T10/00-319r0

LVD Driver Balance for Ultra320 SCSI

Richard Uber
Quantum Corporation

SPI-4 Working Group, Denver, CO
August 24, 2000

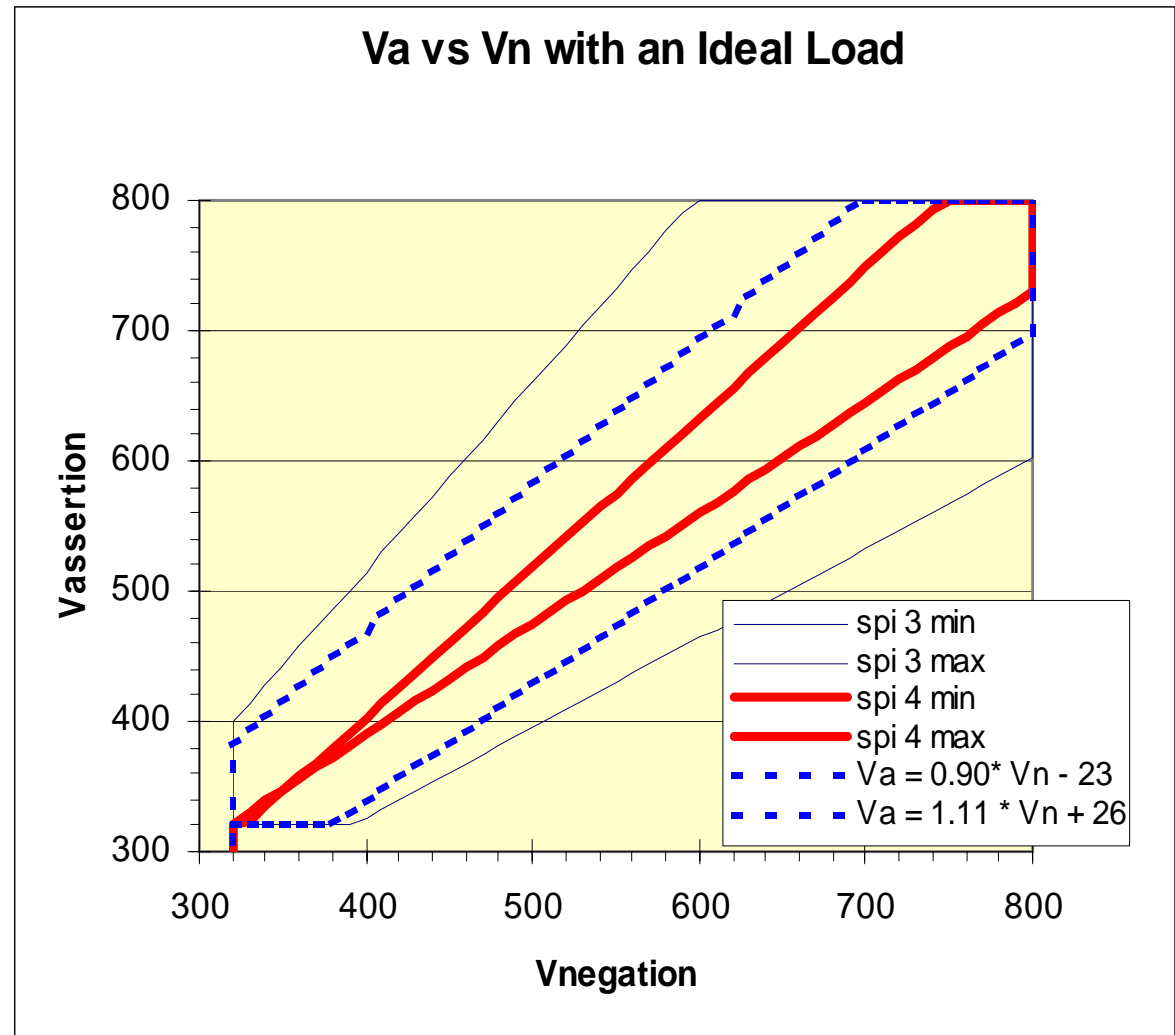
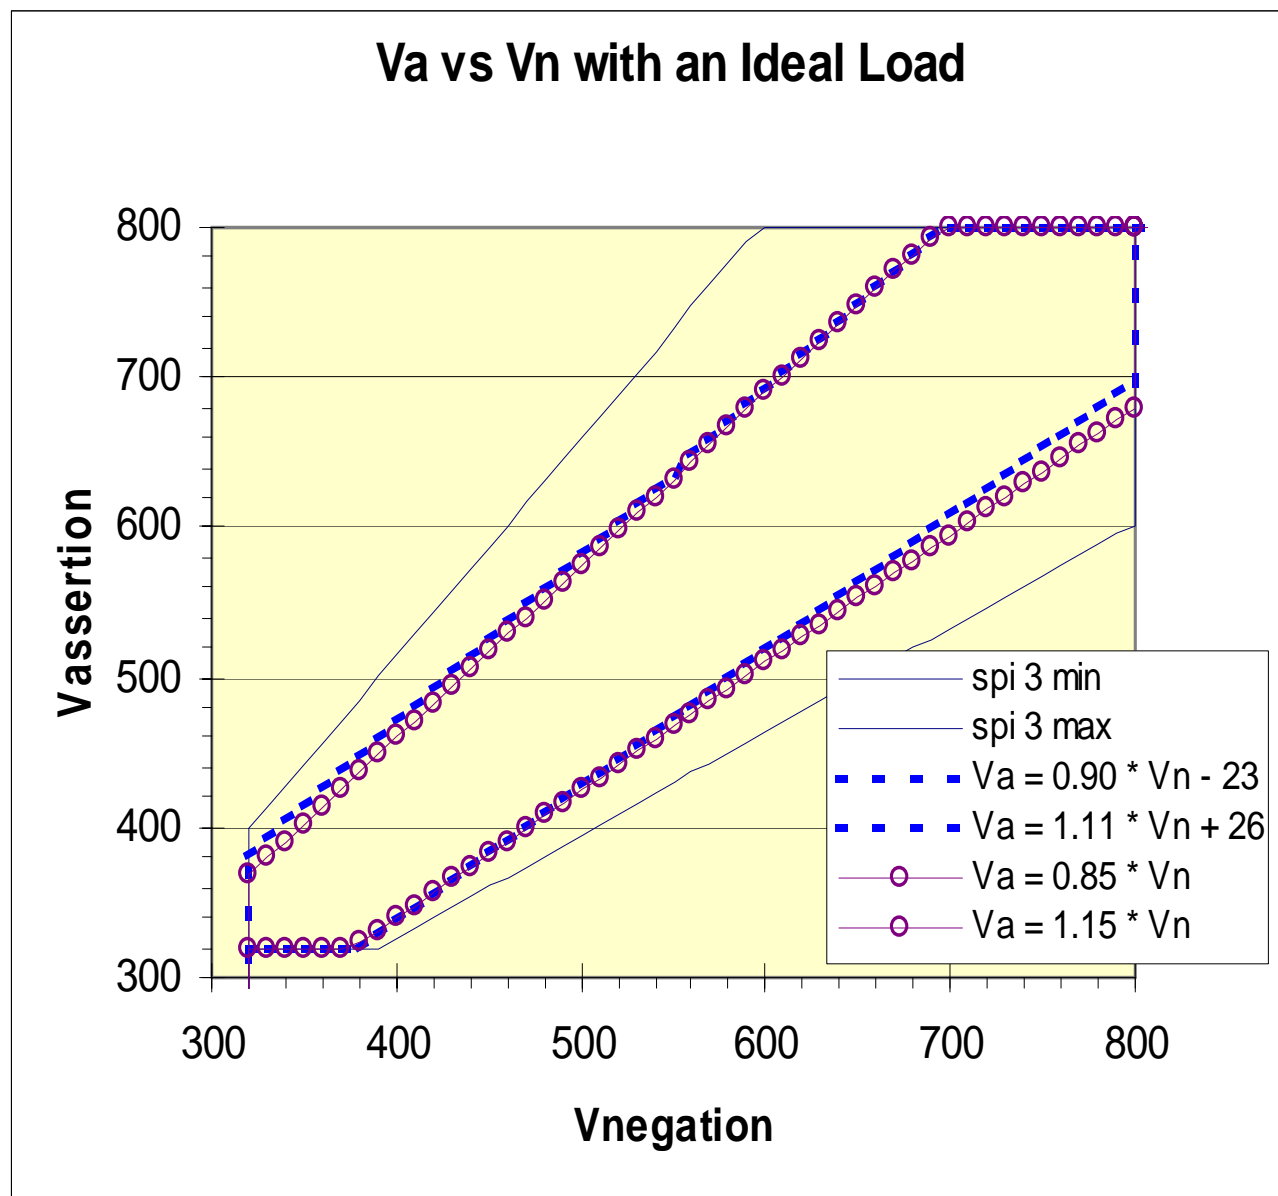
- The proposed equations provide adequate driver balance margin across the full range of drive strengths.
- SPI-4 area =
0.23 * SPI-3 area
- Proposed area =
0.62 * SPI-3 area
- Proposed maximum:
 $V_A = 1.11 * |V_N| + 26$
- Proposed minimum:
 $V_A = 0.90 * |V_N| - 23$
- SPI-4 changes required in:
 - Table A.2
 - Figure A.2

- The proposed range has the same area as the $\pm 15\%$ range of T10/00-276r0.
- The proposed range is more symmetrical about the line $V_A = V_N$.

$$V_{A_min} = 0.90 * | V_N | - 23 \text{ mV}$$

$$V_{A_max} = 1.11 * | V_N | + 26 \text{ mV}$$

- The SPI-4 LVD driver balance equations approved in July are very tight and disallow all existing LVD SCSI devices.
- It is recommended that the driver balance limits for SPI-4 be relaxed but remain much tighter than those in SPI-3.
- The slope of the equations of table A.2 and figure A.2 should reflect the matching of current sources within an IC.
- The offset term in the equations of table A.2 and figure A.2 should reflect the matching of an on-chip current source to an absolute current defined by the load circuit of figure A.1.
- New equations are proposed for Table A.2 in SPI-4 resulting in a wedge diagram in Figure A.2 which has an area that is 62% of the SPI-3 wedge:
 - $V_{A_max} = 1.11 * |V_N| + 26 \text{ mV}$
 - $V_{A_min} = 0.90 * |V_N| - 23 \text{ mV}$
